Access Compliance Report

Public Rights-of-Way

(Curb Ramps)

Intersection ID: 26636	Main Street: SAVANNAH_HILLS_DR	Cross Street: HAMPTON_GLEN_CT	Location: SW
ADA ID: 8D6D2CF0537F	Ramp Type: BlendTrans1	Initial Pass/Fail: Fail	Overall Compliance: No
			Severity Score: 21.25

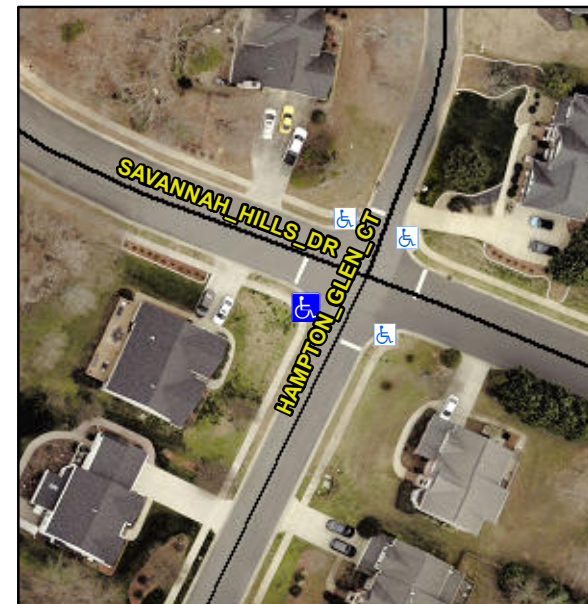
Not Found, R304.5.1, R304.5.3

Compliance	Description	Data	Compliance	Description	Data
N/A	Ramp Length (in)	51.0	Yes	BlendTrans Slope (%)	2.7
No	Ramp Width (in)	45.0	No	BlendTrans XSlope (%)	5.4
N/A	Flare Type LT	N/A	N/A	Flare Type RT	N/A
N/A	Flare Slope LT (%)	N/A	N/A	Flare Slope RT (%)	N/A
N/A	Flare Traversable LT?	N/A	N/A	Flare Traversable RT?	N/A
N/A	Landing Length (in)	N/A	N/A	DWS Provided?	N/A
N/A	Landing Width (in)	N/A	N/A	DWS Contrast?	N/A
N/A	Landing Slope (%)	N/A	N/A	DWS Length (in)	N/A
N/A	Landing X Slope (%)	N/A	N/A	DWS Full Width?	N/A
N/A	Landing Curb? (Y/N)	N/A	N/A	DWS Offset (in)	N/A
N/A	Shared Landing?	N/A			
N/A	Gutter Ponding?	N/A	N/A	Gutter Slope (%)	N/A
N/A	Gutter Lip Ht (in)	N/A	N/A	Gutter X Slope (%)	N/A
N/A	Painted X Walk1?	No	N/A	Painted X Walk2?	No
	X Walk 1 Direction	To SE		X Walk 2 Direction	To NE
	X Walk 1 Width (in)	N/A		X Walk 2 Width (in)	N/A
	X Walk 1 Slope (%)	5.2		X Walk 2 Slope (%)	6.5
	X Walk 1 X Slope (%)	6.1		X Walk 2 X Slope (%)	2.7

N/A	Ramp inside XWalk1?	N/A	N/A	Ramp inside XWalk2?	N/A
	Road Slope (%)	4.2		Clear Space?	N/A
	Road X Slope (%)	7.4	N/A	Clear Space to XWalk (in)	N/A
N/A	Any Obstructions?	N/A	N/A	Storm Grate/Utility Hazard?	N/A
	Obstruction Type			Storm Grate/Utility Type	
		N/A			N/A
			Yes	Surface Condition? (G/P)	Good
			No	Curb Slope (%)	10.2

Remove & Replace Curb Ramp With Two New Directional Ramps or Equivalent.
